**PRELIMINARY/FINAL DRAINAGE REPORT**

**MIDTOWN COLLECTION AT HANNAH RIDGE  
FILING No. 3  
(A Replat of Tract CC, Hannah Ridge at  
Feathergrass Subdivision Filing No. 1)  
PUDSP-20-007**

**Engineering Review**

**EPC Planning & Community  
Development Department**

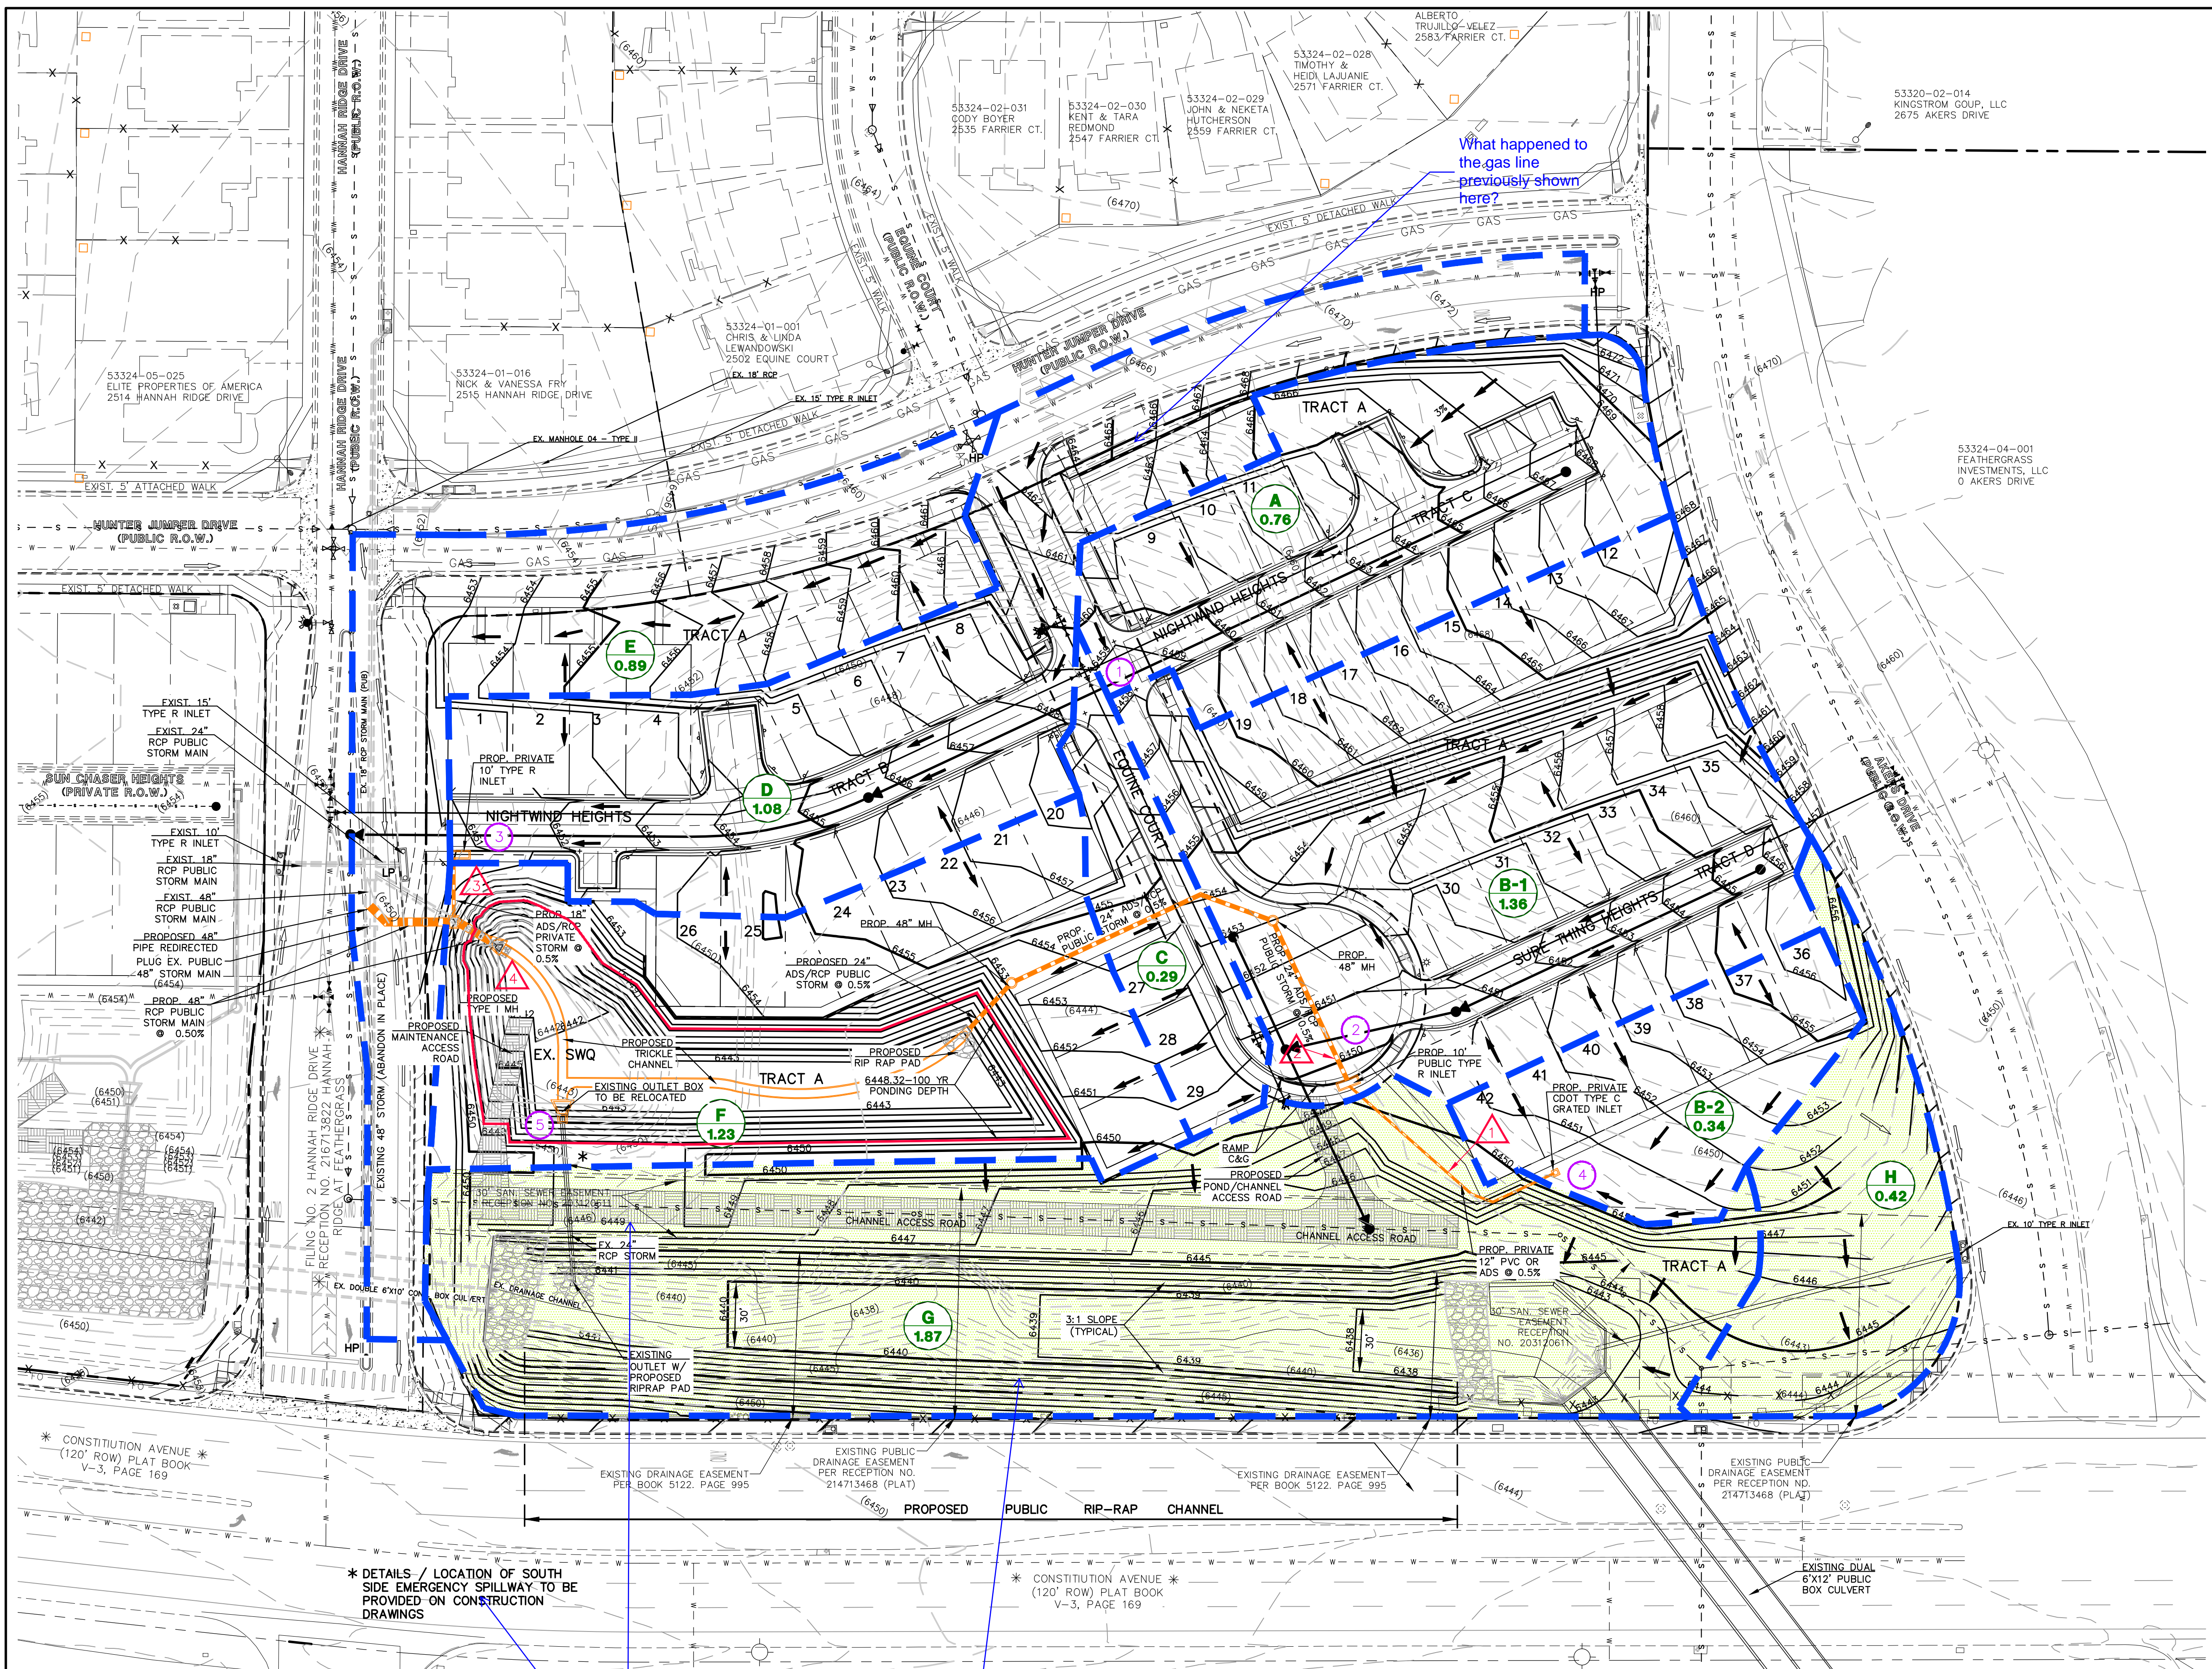
Provide dimensions and cross-sections of the spillway. Final design details and calculations are needed since this is a final drainage report.

Add a label describing the channel improvements and a cross-section of the channel
